Alt APPLICATION No. *590*, 19*77*/BLOCK *436* LOT *17*
(N. B., Alt., Elev., Etc.)

LOCATION *418 1/2 East 9th St.*

DISAPPROVED *June 25*, 19*77* with the following OBJECTIONS:

ALT. APPLICATION No. 590, 19 BLOCK 436 LOT 17
(N. B., Alt., Elev., Etc.)

PLAN OF CELLAR FLOOR
SCALE 1/4" = 1'-0"
93'-11"

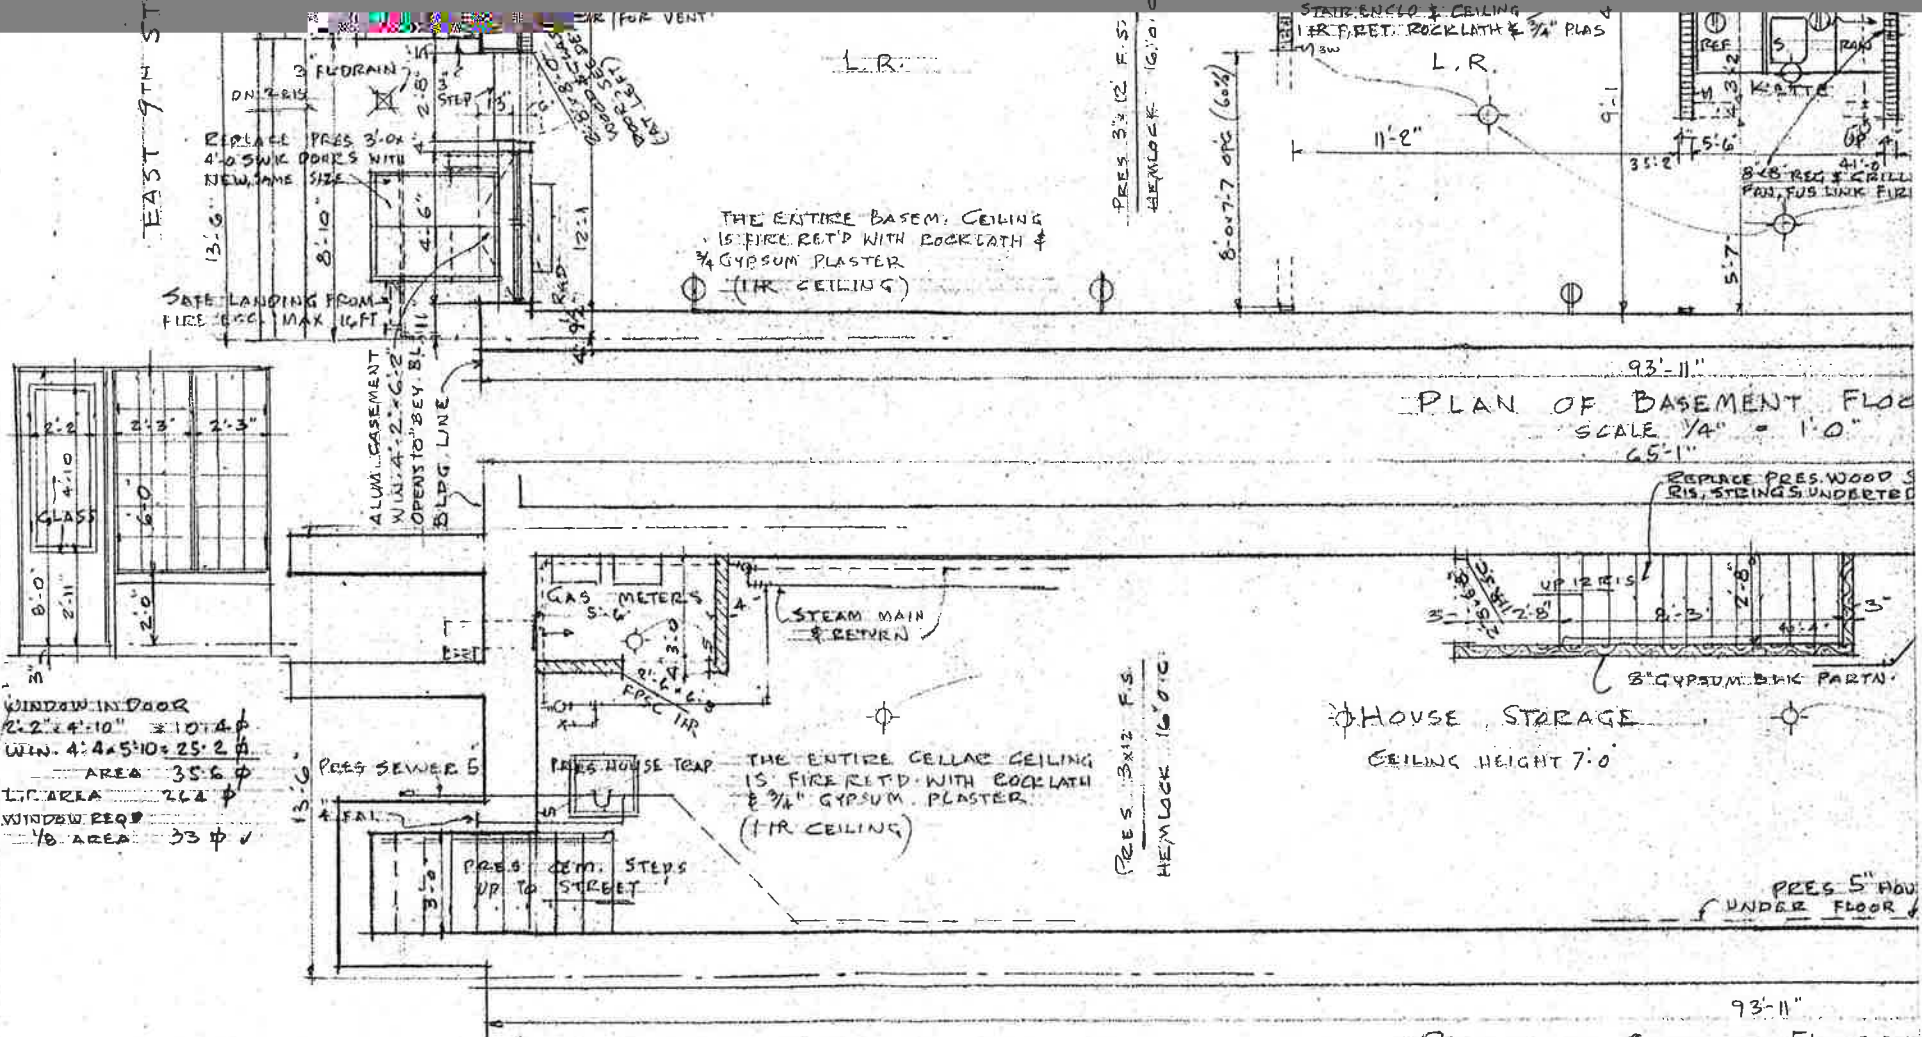
- Spec*
C-1 Correct Spec. sheet.
- C-2 File computation to justify 100#/sq' live load.
- ✓ C-3 clarify two means of egress from cellar.
- ✓ C-4 provide stairway enclosure in cellar.
- ✓ C-5 clarify the ceiling material of the first floor.
- C-6 Provide ventilation in dex.
- ✓ C-7 clarify the thickness of glass of skylight.

- A1) EXTENSION OF COMMERCIAL AREA IN R72 DISTRICT NOT A MATTER OF RIGHT SEC 22.10 ZONAL REGULATION (REMOVED)
- A2) CORRECT SPECIFICATION SHEET ✓
- A3) BATHING IN STORE NOT ACCEPTABLE ✓
- A4) MATERIAL OF BOILER ROOM WALLS ✓
- A5) BOILER ROOM 1 HOUR FPSC SWING OUTWARD ✓
- A6) VENTILATION FOR GAS 1" PER 3000 BTUS ✓
- A7) MANNER OF FIRE RETARDING UNDER FORMER STAIR OPENING ✓
- A8) SHOW ON PLAN COMPLIANCE WITH SEC 61 M2L OUT ✓
- A9) ALL DOORS TO PUBLIC HALL 1 HOUR FPSC ✓
- A10) COMPLY WITH SEC 20.05 HMC LOCKS ON ENTRANCE DOORS STREET TO PUBLIC HALL ✓
- A11) FIRST FLOOR FRONT ROOM COMPLY WITH SEC 30 M2L ✓
- A12) WOODEN OUT BATHROOM DOORS 1/2" ✓
- A13) MANNER OF FIRE STOPPING FIRST FLOOR PUBLIC HALL WALL ✓
- A14) NUMBER OF CHANGES OF AIR. KITCHENETTES BATH ROOMS ✓
- A15) 2 - 1" LAYERS VERMICULITE ON DUCTS ✓
- A16) 40" RIDGE VENT. EXAM TO CONTINUE ✓

THE ENTIRE BASEM. CEILING
IS FIRE RFT'D WITH ROCK LATH &
3/4" GYPSUM PLASTER
(1/2" CEILING)

THE ENTIRE CELLAR CEILING
IS FIRE RFT'D WITH ROCK LATH
& 3/4" GYPSUM PLASTER
(1/2" CEILING)
